**Supplementary Information from AAHK on 3RS EIA Report to ACE EIASC Secretariat  
On Chinese White Dolphins, Fisheries, Air Quality, Noise, Health Impact and Methodology**

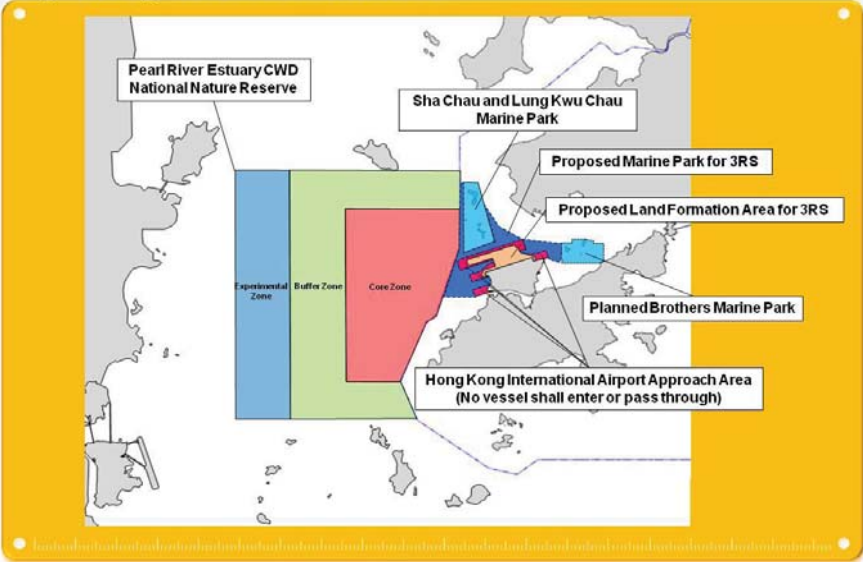
<p>➤ <b>Review the speed limit of the Skypier high speed ferries inside the PRE CWD Nature Reserve in China.</b></p>	<p>SkyPier HSFs must adhere to all relevant speed restrictions both in Hong Kong and in Mainland PRE waters. In the 3RS EIA we are required to focus on the situation and associated controls within Hong Kong waters. Nonetheless, the PRE CWD Nature Reserve in China layout is shown in the attached figure:</p>

Request	Supplementary Information	Relevant Sections in EIA Report
	<p data-bbox="611 411 1487 491"><b>Marine Protected Areas at Pearl River Estuary and Hong Kong western waters</b></p>  <p data-bbox="551 1203 1944 1334">The current SkyPier HSF routing to and from Macau/Zhuhai takes HSFs through the middle of the core zone of the nature reserve. The diversion of such ferry traffic north of SCLKCMP will naturally have the effect of diverting a larger portion of such ferry traffic away from the core area.</p>

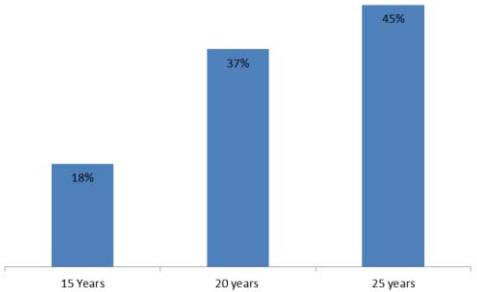
<p>➤ On Noise – noise exceedance at 60-70</p>	<p>Health impact by aircraft noise is evaluated in <b>Section 17.3</b>. In particular, the key health end points of annoyance and self-reported sleep disturbance are assessed in metrics of L<sub>den</sub> and L<sub>night</sub> respectively, rather</p>	<p>Section 17.3</p>

Request	Supplementary Information	Relevant Sections in EIA Report
<p>dB(A) in HZMB case has reckoned health impact; any comparable assessment measures done for 3RS rather than relying on the NEF calculation methodology</p>	<p>than NEF.</p> <p>To our understanding, health impact assessment related to noise was not conducted in the HZMB EIA Study.</p>	
<p>➤ Concerning table 17.3.2, while there would be a net decrease in the overall highly annoyed population, please provide geographical breakdown of the net increase in the highly annoyed population group in the 50 – 55db range and compared thereof with the net decrease in the highly</p>	<p>The HIA analysis on aircraft noise focused on comparing the changes of health impacts between the operation of 3RS and 2RS in 2030, i.e., the year of “worst operation mode”, which represented the maximum total aircraft noise emission. The assessment methodology was developed after a review of relevant practices in Hong Kong and overseas.</p> <p>As described in Section 17.3.3.12 of the EIA Report, taking into account the aircraft noise standard adopted in Hong Kong and the findings of the aircraft noise assessment presented in Section 7.3, the noise sensitive populated districts/regions located adjacent to the NEF25 contour line in year 2030 have been identified as the locations of interest and considered collectively as the assessment area for a quantitative comparison of the 3RS scenario with the 2RS scenario.</p> <p>From the established annoyance analysis, it is noted that the net increase in the highly annoyed population group in the 50-55 Lden, dB range is contributed by exposure in Tung Chung area but this is associated with a reduction of exposure population in the 55-60dB range in Tung Chung in the presence of the proposed mitigation measure of putting the south runway on standby where possible at nighttime between 2300 and 0659.</p>	<p>Section 17.3</p>
